PUBLIC INTEREST REVIEW FOR GROUNDWATER APPLICATIONS

SUBJECT: Application G- 18139 Supersedes review of December 2, 2015
Date of Review(s)

A. GENERAL INFORMATION: Applicant's Name: James M. Warn County: Clackamas

A1. Applicant(s) seek(s) 0.67 cfs from 1 well(s) in the Willamette Basin,
Molalla-Pudding subbasin

Water-Level Trends in Nearby Wells

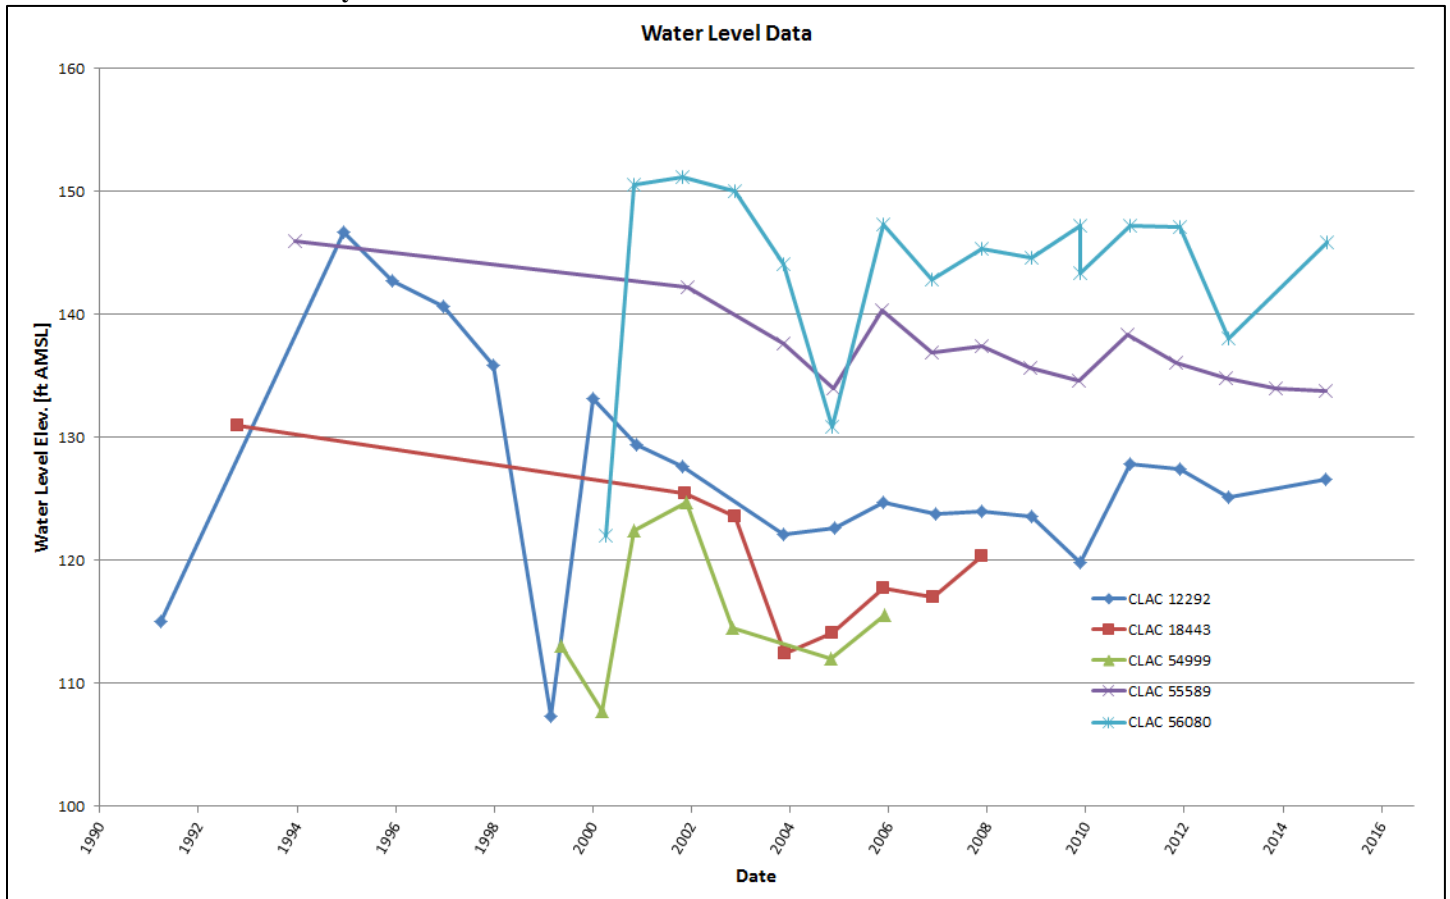
Observations from nearby wells (CLAC 12292, CLAC 18443, CLAC 54999, CLAC 55589 and CLAC 56080) indicate relatively stable long-term trends for alluvial wells in the immediate vicinity of CLAC 18025 (see attached hydrograph).

Transient Stream Depletion

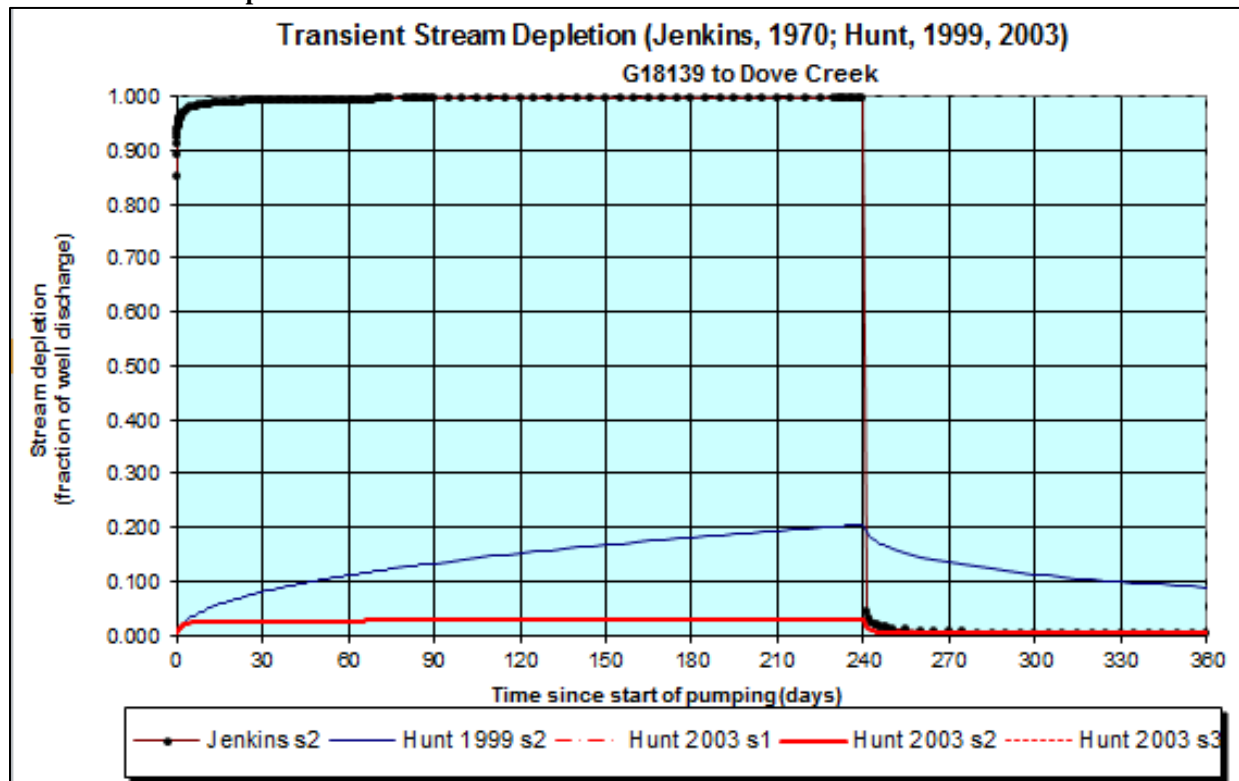
Comments: Interference at 30 days was estimated using the Hunt 2003 model. The presence of low permeability Willamette Silt between the aquifer and the streambed results in an inefficient connection between the aquifer and the stream, therefore the interference at 30 days is much less than 25%. However, stream depletion will increase over time until all of the pumped water is reduced stream flow.
